APPENDIX C:  
TREE REPORTS

**RE: Tree Inventory & Assessment at Leigh Creekside Park Improvement Plan**

**Tree Inventory & Preliminary Park Improvement Plan**  
**Leigh Creekside Park**  
LAFAYETTE CA

**Re: Leigh Creekside Park Improvement Plan**

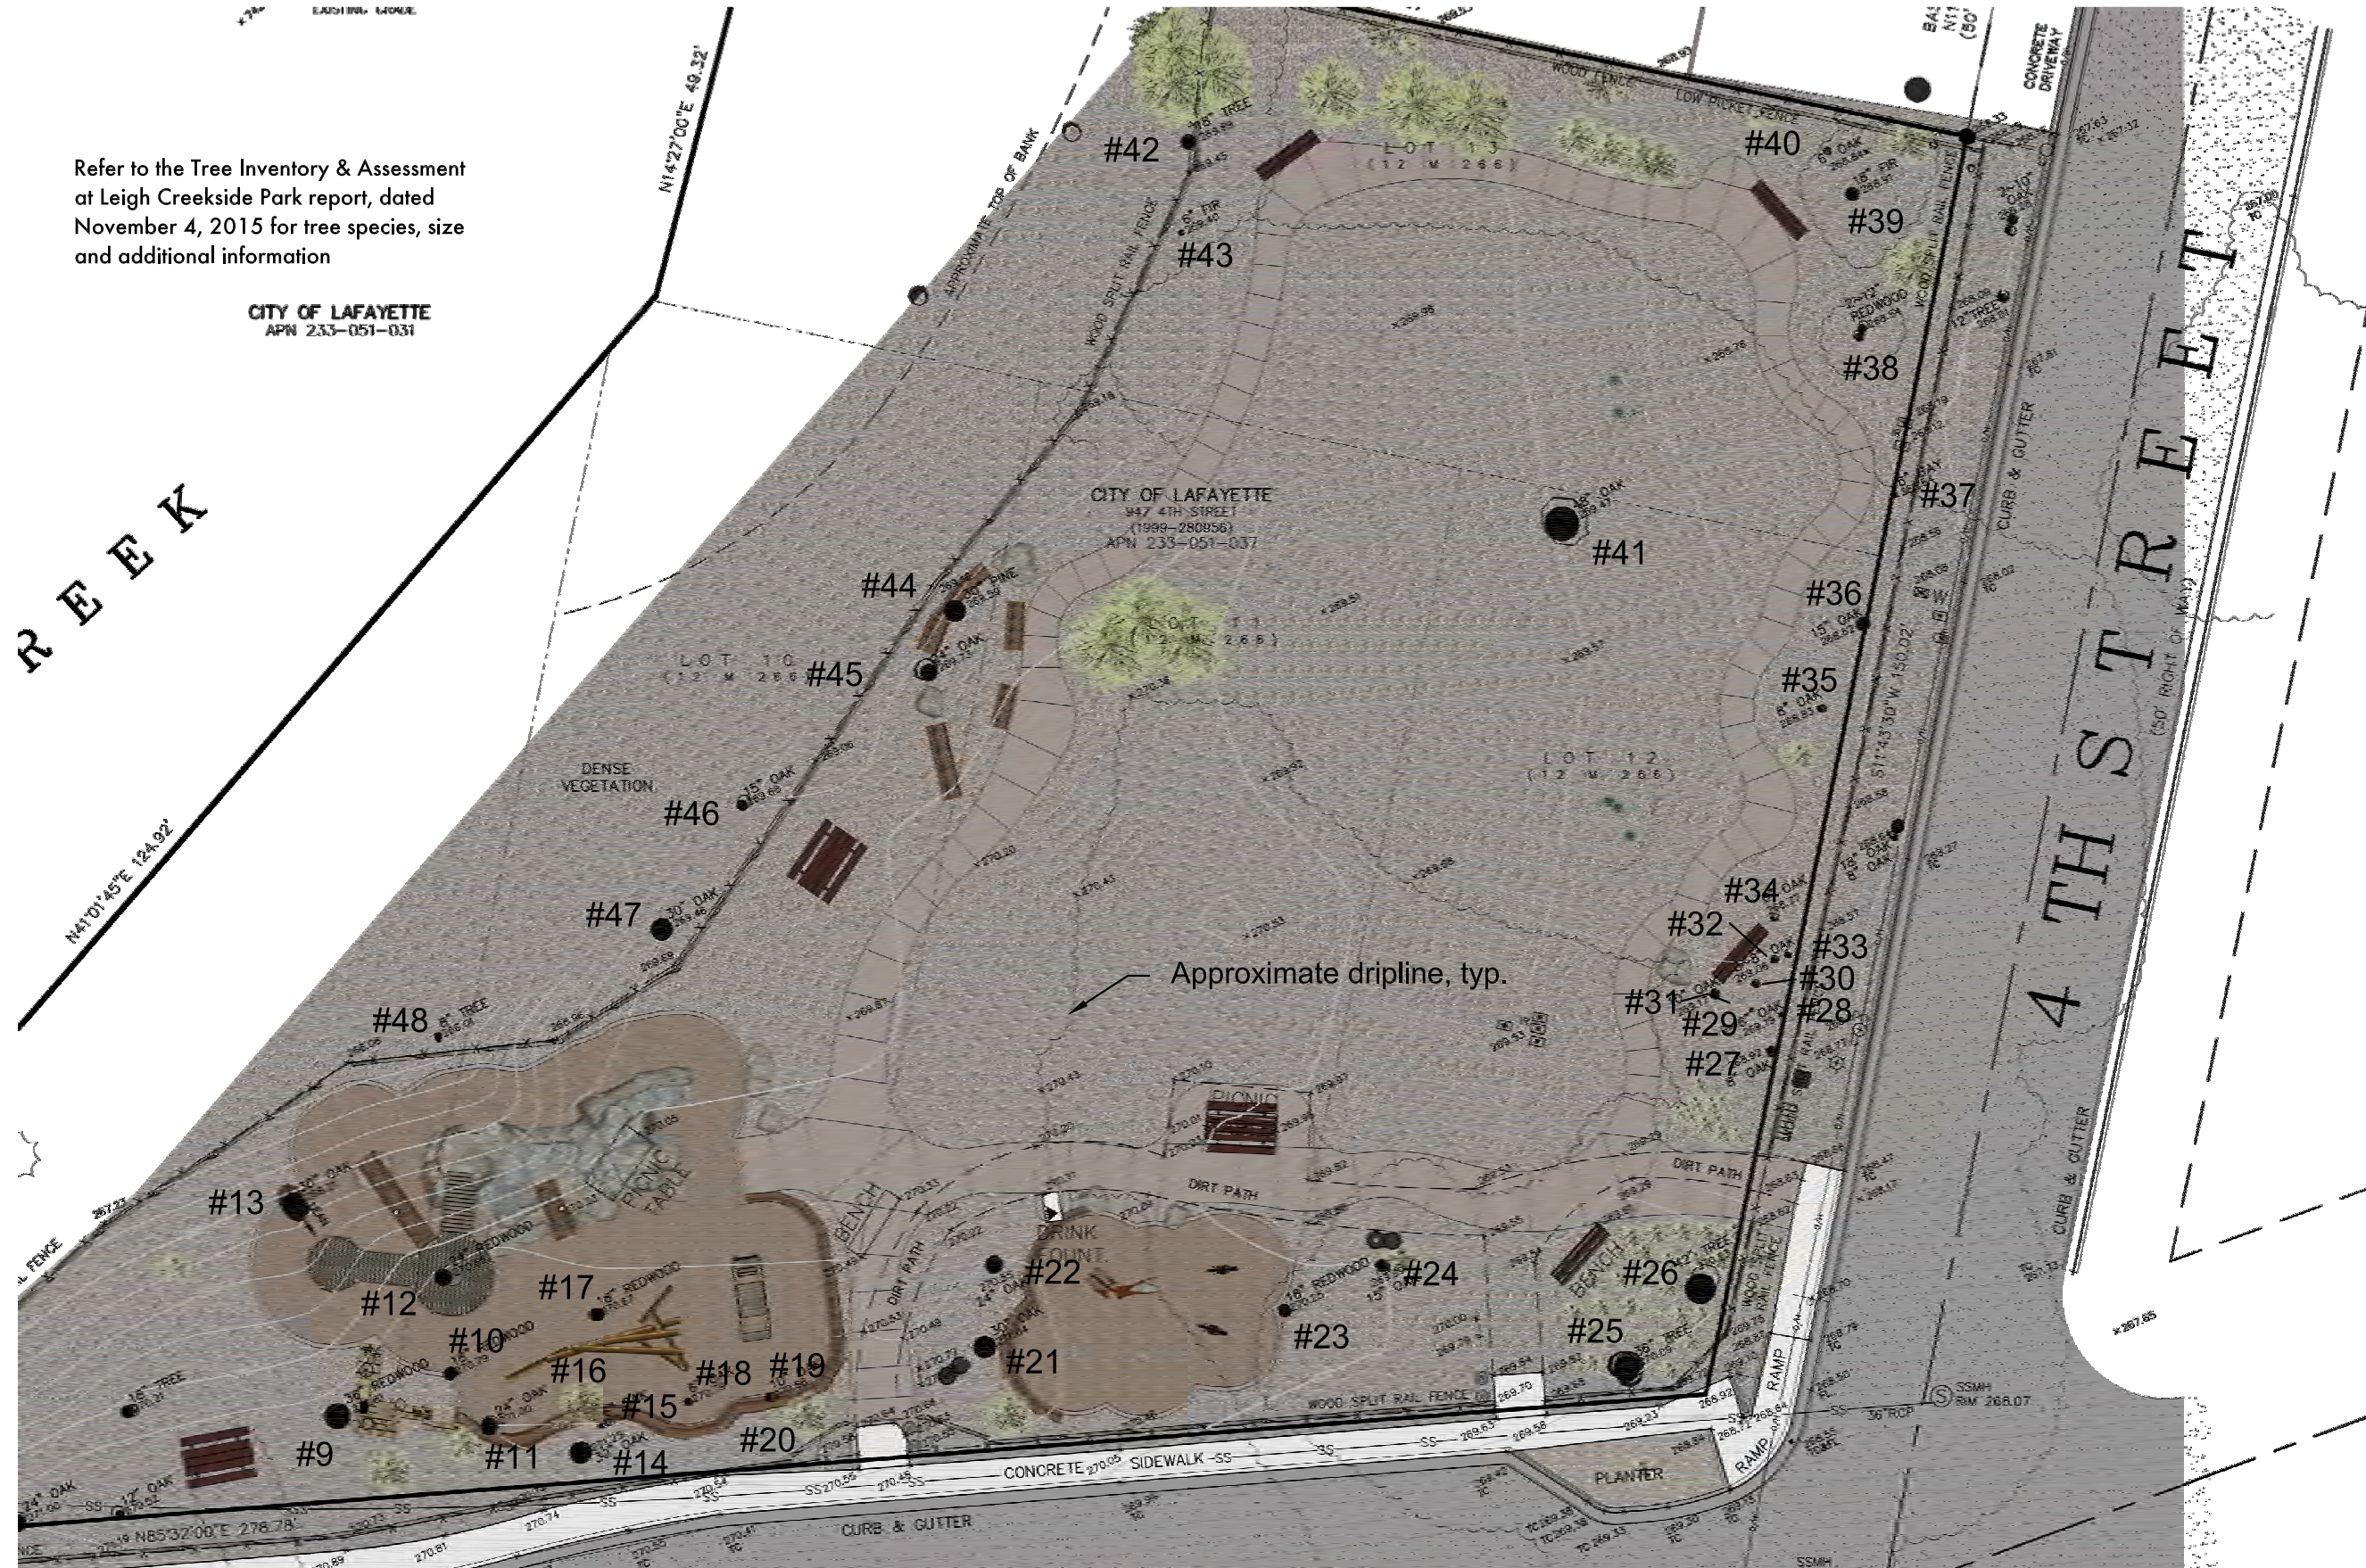
#	SPECIES	DIA	H	S	OBSERVATIONS / RECOMMENDATIONS	IMPACT
9	Redwood, <i>Sequoia sempervirens</i>	40"	3	4	Located 6 feet south of the proposed concrete curb the borders the Time Zones 4, 5, 6 play area. Pioneer Time Town Square located adjacent to tree. <i>To minimize root disturbance, keep any grade disturbances a minimum of 10 feet from root crown. See Trees that Merit Special Consideration below.</i>	Moderate
10	Incense cedar, <i>Calocedrus decurrens</i>	18"	1.5	3	Significant dieback throughout lower canopy. Likely suffering from drought. Consideration for tree removal may be warranted. Proposed curb edging for play area shown at root crown. <i>Supplemental watering may benefit tree. See Trees that Merit Special Consideration below.</i>	Significant
11	Coast live oak, <i>Quercus agrifolia</i>	19.5"	3	2.5	Leaf production limited to upper canopy due to crowding of adjacent trees. Tree encompassed within proposed rubberized flooring and log seating. <i>See Trees that Merit Special Consideration below.</i>	Significant

#	SPECIES	DIA	H	S	OBSERVATIONS / RECOMMENDATIONS	IMPACT
12	Incense cedar, <i>Calocedrus decurrens</i>	27"	3	2.5	Leans to east. Moderate dieback throughout lower canopy. Crowded. Proposed elevated deck surrounds central leader. <i>Given the elevated feature of deck, it appears the grade below may remain undisturbed (10 foot radius). Adjacent grading for rubber flooring may adversely impact tree. Given poor condition of tree, reconsider designing play feature around tree. Supplemental watering may benefit tree.</i>	Minor- Moderate
13	Coast live oak, <i>Quercus agrifolia</i>	31"	3.5	3	Bifurcates at 14 feet above grade. Mechanical damage noted along lower trunk (gun shots, knife wounds?). Leans eastward. Proposed concrete curb that edges rubber flooring runs into base. <i>Remove California bay sapling at root crown. See Trees that Merit Special Consideration below.</i>	Significant
14	Valley oak, <i>Quercus lobata</i>	25.5", 7", 11"	3.5	3	Crowded by adjacent tree #15, 3 feet to north. Epicormic shoots <sup>1</sup> beginning to emerge. Located 18" from log seat and rubberized flooring. <i>See Trees that Merit Special Consideration below.</i>	Moderate to significant

15	Valley oak, <i>Quercus lobata</i>	8"	2.5	3	Broken leader 6 feet above grade with potential decay. Northern 4" dia. leader in decline. Located within proposed rubberized flooring. <i>Removal would likely benefit tree #14. See Trees that Merit Special Consideration below.</i>	Moderate to significant
16	Coast live oak, <i>Quercus agrifolia</i>	4"	2.5	2.5	Crowded. Located within proposed rubberized flooring. <i>Removal would likely benefit tree #14. See Trees that Merit Special Consideration below.</i>	Moderate to significant
17	Incense cedar, <i>Calocedrus decurrens</i>	18"	3	2.5	Moderate dieback throughout lower canopy. Crowded. Proposed rubberized flooring encompasses root crown. <i>See Trees that Merit Special Consideration below.</i>	Significant

#	SPECIES	DIA	H	S	OBSERVATIONS / RECOMMENDATIONS	IMPACT
18	Coast live oak, <i>Quercus agrifolia</i>	8"	2.5	2.5	Crowded. Subdominant tree. Sparse foliage. Proposed rubberized flooring encompasses root crown. <i>See Trees that Merit Special Consideration below.</i>	Significant
19	Coast live oak, <i>Quercus agrifolia</i>	11"	3.5	3	Poor branch union at 7 feet above grade where central leader splits to three. Epicormic shoots <sup>1</sup> beginning to emerge. Proposed rubberized flooring encompasses root crown. <i>See Trees that Merit Special Consideration below.</i>	Significant
20	Coast live oak, <i>Quercus agrifolia</i>	5"	3	3	Subdominant tree. Proposed log seat and rubberized flooring located 18" away. <i>See Trees that Merit Special Consideration below.</i>	Moderate to significant
21	Valley oak, <i>Quercus lobata</i>	33.5"	4	3	Majority of canopy grows over Moraga Boulevard due to crowding. Proposed log seat and rubber flooring located less than a foot away from root crown. <i>See Trees that Merit Special Consideration below.</i>	Significant

22	Valley oak, <i>Quercus lobata</i>	19"	4	3	Canopy grows northward due tree #21 to south. Proposed log seat and flooring located 2 feet from tree. <i>Remove bay at root crown. See Trees that Merit Special Consideration below.</i>	Moderate to significant
23	Incense cedar, <i>Calocedrus decurrens</i>	19.5"	2.5	3.5	Limited canopy to east due to presence of tree #24. Proposed concrete edging and flooring. <i>See Trees that Merit Special Consideration below.</i>	Moderate to significant

24	Coast live oak, <i>Quercus agrifolia</i>	17"	3	3	Minor mechanical damage along lower trunk. Proposed concrete sidewalk located 7 feet from root crown. In an effort to minimize root damage provide a min. clearance or 15 feet from base of tree. <i>Remove existing bay at root crown. See Trees that Merit Special Consideration below.</i>	Moderate
25	Cork oak, <i>Quercus suber</i>	18.5", 17", 22.5"	4.5	2.5	Located near the intersection of Moraga Blvd & 4th Street. Western 18.5" leader grows 45 degrees to the grade & over sidewalk. Majority of canopy grows to west due to adjacent cork oak. <i>City may wish to have tree periodically inspected by an arborist due to sidewalk location.</i>	None
26	Cork oak, <i>Quercus suber</i>	25", 29"	4.5	3	Codominant branch union 4 feet above grade with included bark <sup>2</sup> . Proposed concrete walk located 7 feet from root crown. <i>Retain an arborist to be on-site for any excavations required for proposed walkway. Consider a porous concrete, decomposed granite or walk with minimum excavation specification (i.e. geotextile application) to minimize root disturbances.</i>	Minor to moderate

Grove consisting of a young stand of oaks that are growing in close proximity to one another (18 inches to 4 feet) which is adversely affecting their health and structure. Selective removal of individual species may benefit grove. Erect Tree Protection Fencing prior to the commencement of any grade disturbances to protect trees. Retain arborist to identify potential conflicts with footing for proposed bench that comes in close proximity to tree #30 through 34. Remove boulder feature at tree #31 to minimize root disturbance.

Excavation for the proposed concrete curb and base preparation for the rubberized 'fall zone' flooring material at the play structures will place an adverse impact on the existing trees. In particular, the existing valley oaks and coast live oaks are noted as being sensitive to addition of fill around base of trunk (Clark, J., and N. Matheny. 1997. *Trees and Development*). Per conversations with the project architect, it appears the concrete curbing may be substituted with the horizontal log seat. Concerns still exist, however, if excavation is required to prevent the logs from rolling and whether they will allow for positive drainage away from the oaks and rubber flooring. Beyond the detrimental effects that excavation may place on the trees' root systems, additional concerns exist regarding whether adequate oxygen exchange can take place if the top layer of soil is covered with the rubberized flooring material.

In an effort to reduce impacts on the existing trees, additional studies are warranted to relocate the proposed structures away from existing trees to remain.

In an effort to protect and minimize disturbance to the existing heritage oak, consider revising the layout of concrete path so that it does not encircle the oak. It appears the northern extension of the path can be relocated to the southern dripline of the tree. While this would significantly alter the proposed layout and extension of the path, it would minimize activity under the oak's canopy, help maintain the privacy for the adjacent homeowner at 959 4<sup>th</sup> Street (whom expressed this concern during the site visit), remove any potential root disturbances, and minimize potential vandalism (a number of the trees located closer to the existing active areas have had their bark carved or have been mechanically damaged).

An alternate design study may be to provide an 'out and back' path to the west side of the tree where a greater clearance from the root crown can be achieved.
